FINAL REPORT

Crude Oil Storage Tank 8 Floor and Cathodic Protection System Design Review

PWSRCAC Contract # 5056.22.01

June 2022

Figure 4 – Annular Ring CP Groundbed

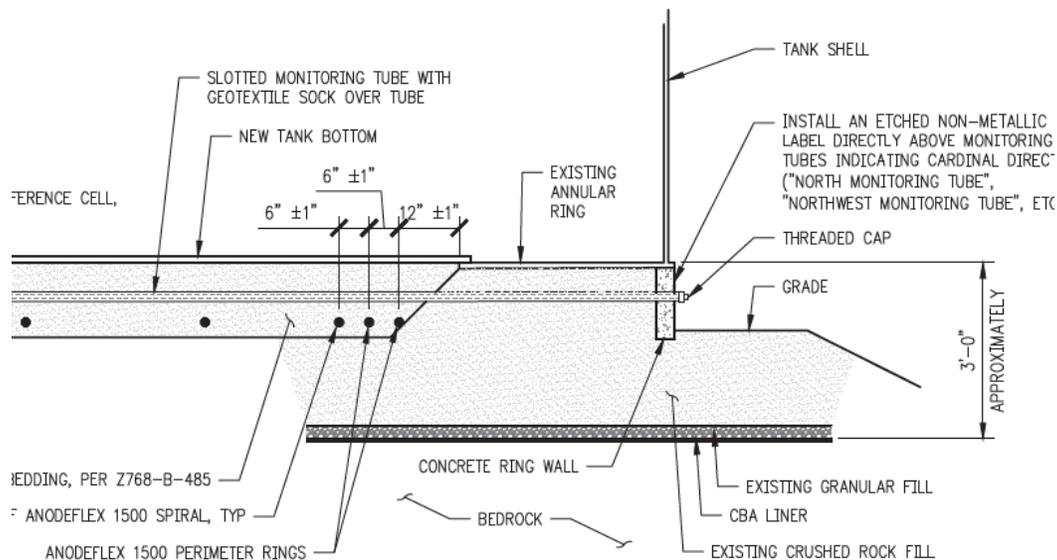
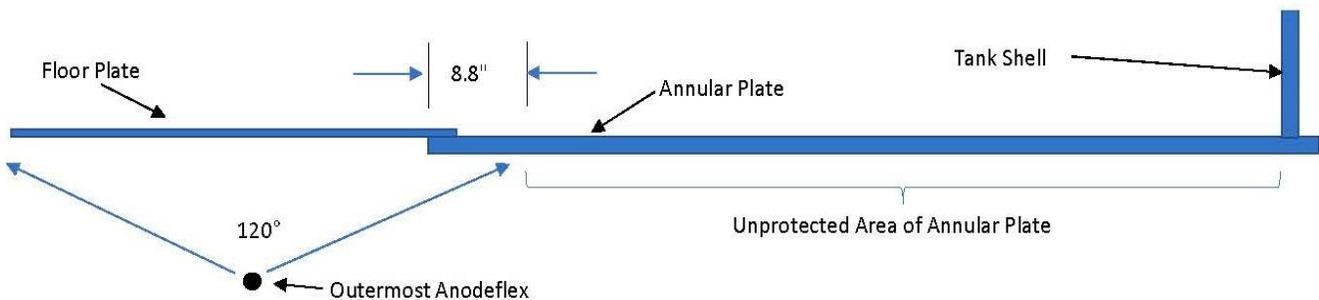
The ground bed design for the new Tank 8 floor CP system, consists of Anodefex rings distributed throughout the area beneath the tank floorplate. The CP design includes two separate anode flex loops intended to protect the tank's annular plates. However, in that design, the annular ring Anodefex loops are located beneath the floorplate, not beneath the annular plate. They are located roughly 1-foot from the inside diameter of the annular plate (see Figure 4, excerpted from drawing D-54-Z768-CP101).

This configuration is unlikely to protect the annular plates for the following reasons:

First, the annular plate and floorplate are welded together and therefore electrically continuous. The Anodefex loops intended to protect the annular plates will distribute current primarily via the lowest resistance pathways. In this case, assuming similar backfill resistivity, the current will go to the closest steel, which is the regular floorplate steel, not the annular plate.

A general rule of thumb, used for designing uniform distribution of CP current for close coupled anodes, is to assume that the anode will distribute current to the steel surface in a (roughly) 120-degree arc of influence.¹ This is depicted below in Figure 5. As shown in the figure, the Anodeflex loops intended to protect the annular plate, will only impact a small section of the annular plate that is located closest to the Anodeflex (also depicted in Figure 5).

Based on this geometry, over 85% of the soil-side surface area of the annular plate is likely to remain unprotected from corrosion with the proposed cathodic protection design.

The two Anodeflex loops that are dedicated for the annular plate are tied to a separate circuit that can be adjusted independently of the floorplate system. It appears that APSC will attempt to protect the annular plate by using a higher driving voltage on the dedicated Anodeflex loops. This approach is very unlikely to be effective. As discussed above, the Anodeflex loops dedicated to protecting the annular plate are much closer to the floorplate than they are to the annular plate. Even with the ability to independently power the annular plate Anodeflex loops, the resulting CP current will go predominantly to the perimeter floorplate and will not measurably increase the annular plate area impacted by cathodic protection.

The CP designer appears to recognize this shortcoming in the design. Within the document "Cathodic Protection Calculations Annular Ring Circuit," Section 3.0, "Assumptions," the designer included the following statement: "Anodeflex will not be installed directly under the annular ring due to construction restraints; therefore, reduced CP current density is expected near the shell."

To ensure protection of the annular plate using an anode depth of 12-inches, it would be necessary to modify the design to relocate the two outermost Anodeflex loops so that they are beneath the annular plate. The outermost loop would need to be located within about 20 inches of the concrete ringwall and the second loop would need to be located within roughly 60 inches of the ringwall. See Figure 8.

This configuration would provide sufficient current and current distribution to the annular plate. It would also correct for the deficiencies associated with anode crowding. As with the proposed design, these anode rings should be designed such that the voltage and current driving them can be adjusted independently of the remainder of the soil-side CP system.

Figure 6 – Annular Ring CP Groundbed Spacing

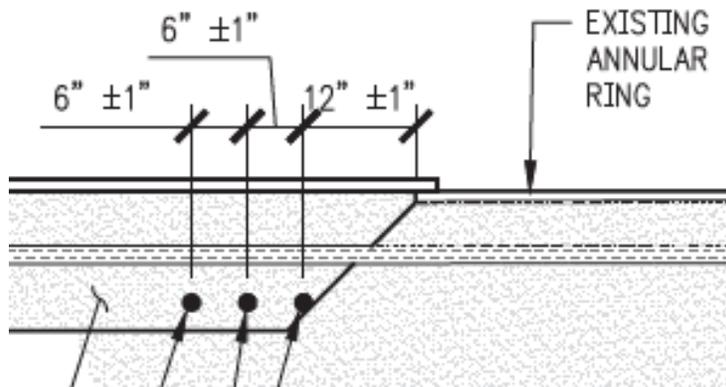
However, the preliminary annular plate CP system design includes placing the outermost three anode loops very closely spaced together (6 inches apart) as shown in Figure 6 (excerpted from drawing D-54-Z768-CP101). The two outermost rings are dedicated to protecting the annular plate. The innermost of the three rings is intended to protect the floorplate.

The CP system designer appears to have correctly calculated the annular plate anode resistance for a single isolated Anodeflex ring. However, at that point the designer divided the resistance by the number of anodes (Figure 7). The calculation note in Figure 7 suggests that that calculation negates the effect of close-coupling or crowding the anodes. That is not the case. The calculation in Figure 7 is intended for anodes that are widely spaced and not subjected to the impacts of crowding.² It does not account for the increase in circuit resistance that will accompany installing those anodes as closely as designed.

The designer should have utilized a modified Sunde Equation to calculate the added resistance that will occur due to mutual interference between closely spaced anodes.

We have run these calculations using soil resistivities that are typical of what would be expected for clean graded fill. Based on the results of those calculations, the rectifier included in the design will not have sufficient voltage to overcome the resistance caused by the anode crowding.

Figure 9 – CP Monitoring Tube Detail

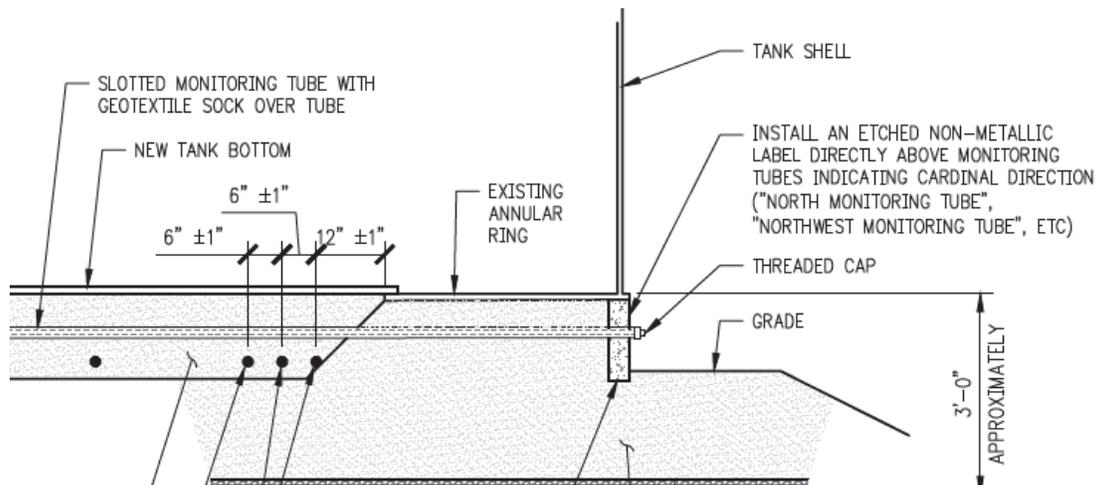
The new CP system design appears to correct this shortcoming. Figure 9 is an excerpt of preliminary design drawing D-54-768-CP101, showing the proposed monitoring tube. It appears that APSC intends to install slotted tubes beneath the annular plate as well as the floorplate. That will enable APSC to monitor the levels of cathodic protection on the annular plate as well as the floorplate. This represents a design improvement over the existing systems.

Figure 10 – Sump/Secondary Containment Liner Details

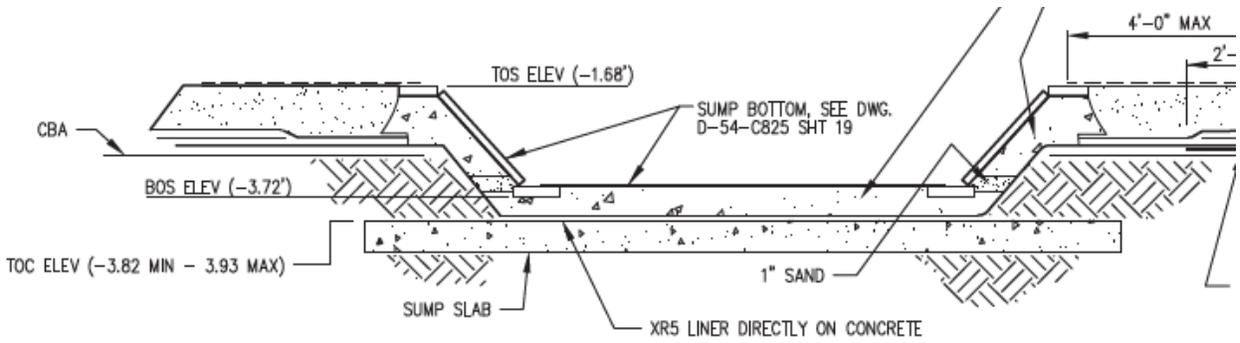
Both the existing and new CP systems are not configured to protect the steel associated with the bottom of the tank sump. The sump rests within a few inches of the secondary containment liner. That close proximity precludes the installation of anodes beneath the sump. Figure 10 is an excerpt from APSC design drawing D-54-C285 Sheet 20, showing the sump location relative to the secondary containment liner (shown as "XR5 Liner" on the drawing excerpt).

The design details provided by Alyeska and depicted in Figure 10, confirm that there is not sufficient clearance to accommodate anodes between the sump bottom and secondary containment liner. Figure 11 (an excerpt from design drawing D-54-Z768-CP102 Sheet 1) shows the routing of anode material around the sump to accommodate the lack of clearance. No anodes will be installed directly beneath the sump. Based on this configuration, the soil-side surfaces of the sump bottom will not see any benefit from the new cathodic protection system.

- Anodes should be designed and installed to be mounted on the internal surfaces of the sump floor.
- The new sump should be fabricated outside of the tank and the soil-side surfaces of the assembly should be coated prior to installation.
- The designer should consider the impacts of anode crowding at the sump. Based on those calculations, they may want to modify the design proposed in Figure 11 to alleviate anode crowding issues.
- Alyeska should consider an additional corrosion allowance for the sump by fabricating the sump from thicker steel than the remainder of the floor.

Figure 11 – Anode Distribution Around the Tank 8 Sump

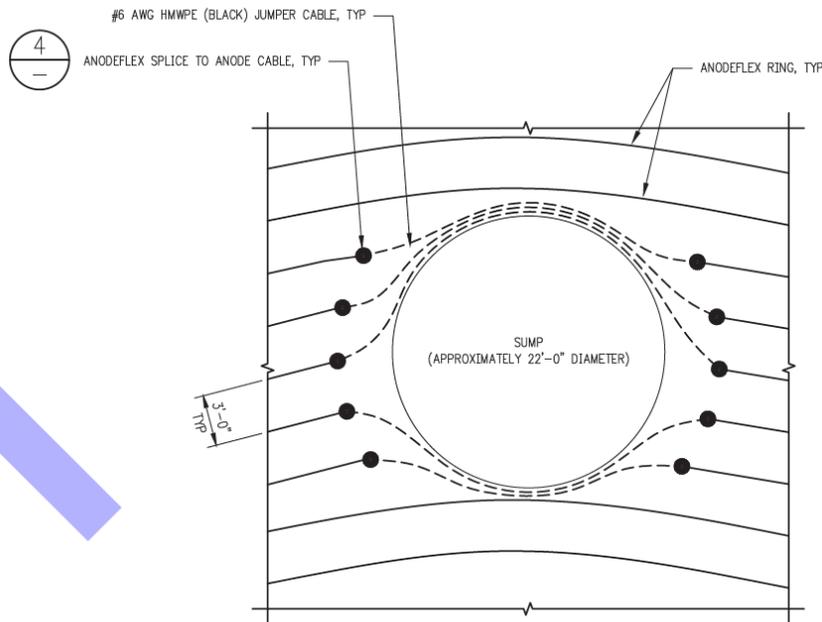
The output of the anode placed as shown in Figure 11 will also be impacted by the crowding effect of placing three or four Anodeflex rings in such close proximity (similar to the situation discussed in Section 3.3 of this report). The result will be that significantly less current will be distributed to this area.

Figure 12 - Column Base Anode Routing

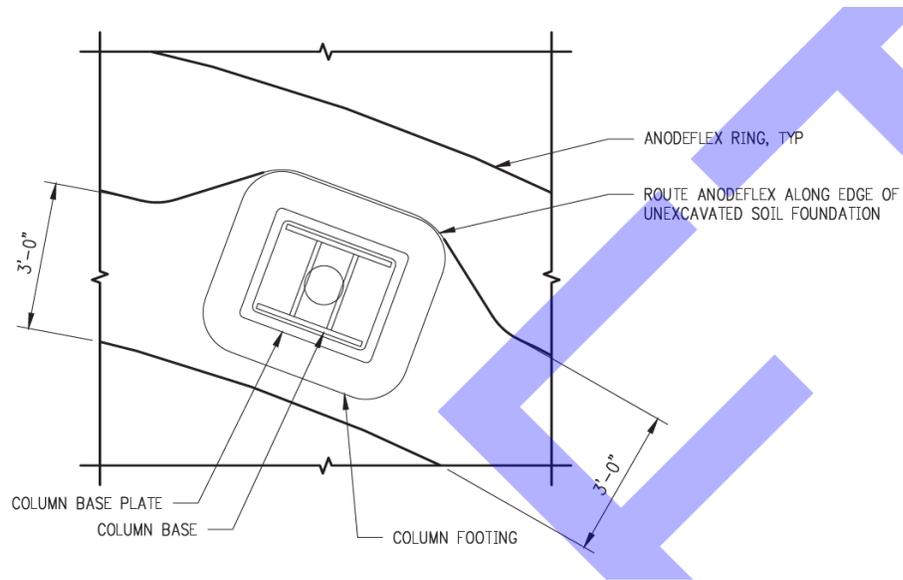
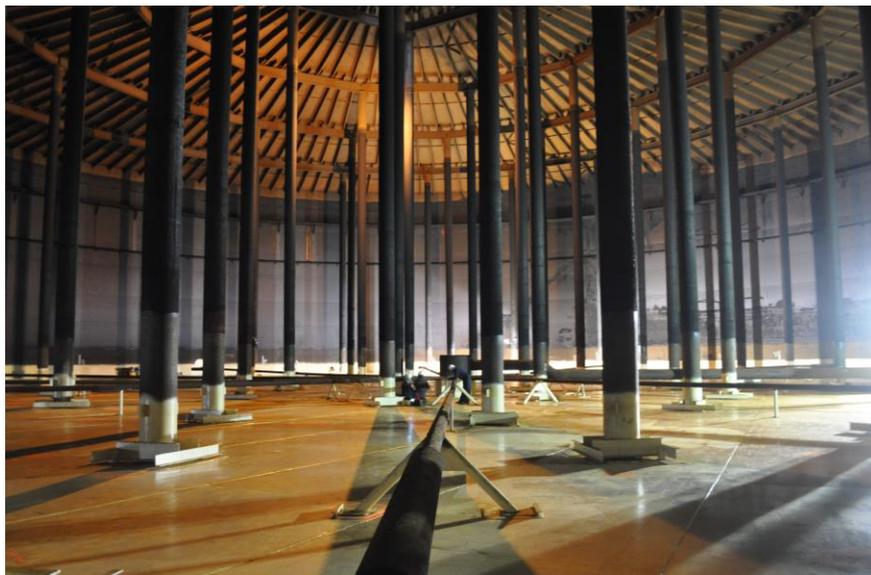
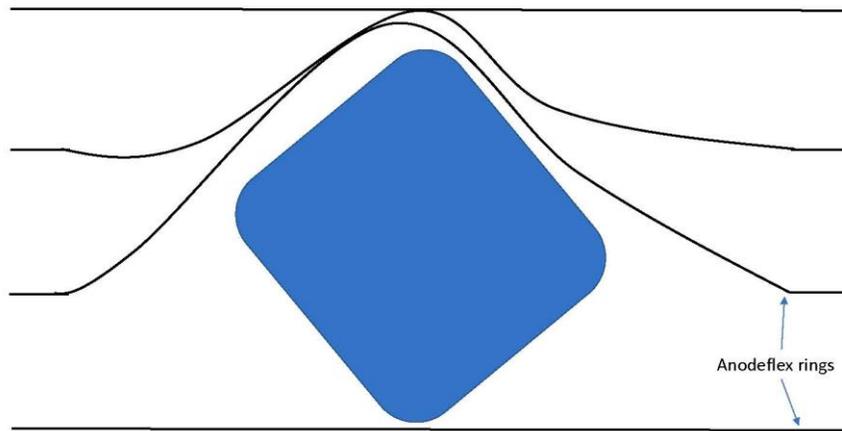
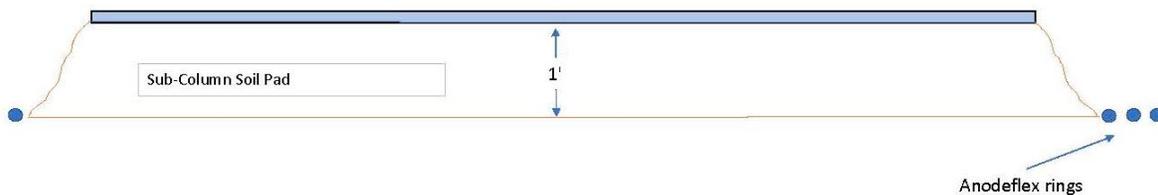
Neither the existing nor new CP system designs are configured to afford full protection of the steel beneath the tank columns. The new CP system design includes routing the Anodeflex material around the soil pads beneath the columns (see Figure 12).

Figure 12, excerpted from drawing D-54-Z768-CP104, presents the best-case scenario for how far the Anodeflex rings will need to deviate to avoid column base pads. In Figure 12, the column base is aligned in parallel to the Anodeflex rings. However, as shown in Figure 13, the column bases are not all oriented the same. In some cases, the column bases may be oriented perpendicular or diagonal to the Anodeflex rings as depicted in Figure 14.

The design doesn't include dimensions of the existing column pad remnants that will be left in place or the dimensions of the column feet. Without those dimensions, we can't define the exact impact to anode spacing. However, the presence of a column base that is diagonal to the Anodeflex rings could shift the location of two or more anode rings.

- Current from the Anodeflex rings located at the toe of the column pads will go to the area immediately above the anodes and not reach the floorplate directly beneath the columns (similar to the situation described in Section 3.2 of this report).
- Placing two or more anode rings in close proximity at the toe of the pad will create a "crowding" issue. The sections of Anodeflex rings that are too closely co-located will not provide current to that area (similar to the situation described in Section 3.3 of this report).

- The design should be modified to allow installation of the Anodeflex rings beneath the columns. That would alleviate issues with anode crowding and ensure uniform current distribution.
- The design should ensure that the floorplates beneath the columns are fully seal welded prior to setting the column pads to ensure that the pads are truly doubler-plates. That may already be the intent of the design, but it was not entirely obvious in the design documents.
